SIB 65 08 25

2025-04-28

INTERMITTENT FAILURE OF CID SIDE OF MULTIFUNCTION DISPLAY

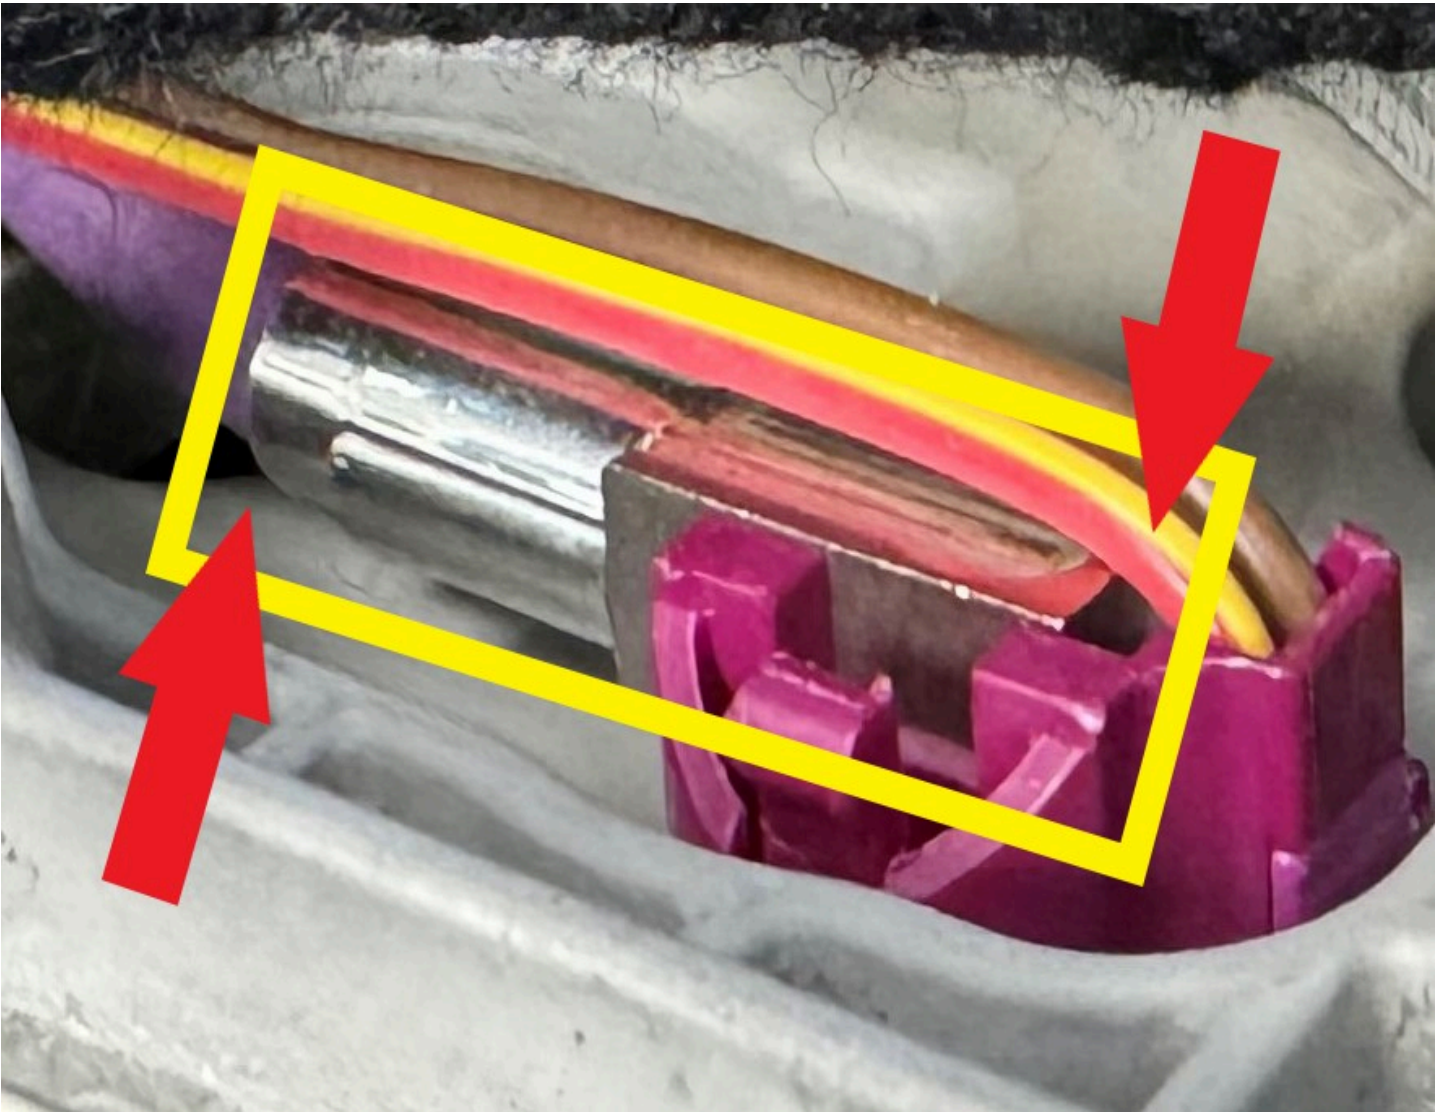
The wiring in Connector A664*1B (LVDS data line) may be under excessive tension.

1. Before carrying out a Vehicle test, access Connector A664*1B the Multifunction Display as per **Repair Instructions 65 50 210 – “Removing and installing instrument cluster”**.
2. Check the tension of the wires at pins 5 and 6 on Connector A664*1B in the location shown in the picture below

4. If the wiring does NOT have excessive tension or the tension has been relieved during a previous repair, then continue with standard diagnosis.
5. If the wires on Pins 5 and 6 are taut, unwrap the wiring harness cover by approx. 3 cm or up to the start of the metal sleeve of the LVDS data line

Modify the wiring harness at Connector A664*1B on the Multifunction Display.

5. This will allow for a release of the excessive tension on the wires and plug connection.
6. Because of the sharp edges on the metal sleeve the LVDS data line, a protective tape must be attached to the area of the metal sleeve in the harness to prevent chafing of the wiring.
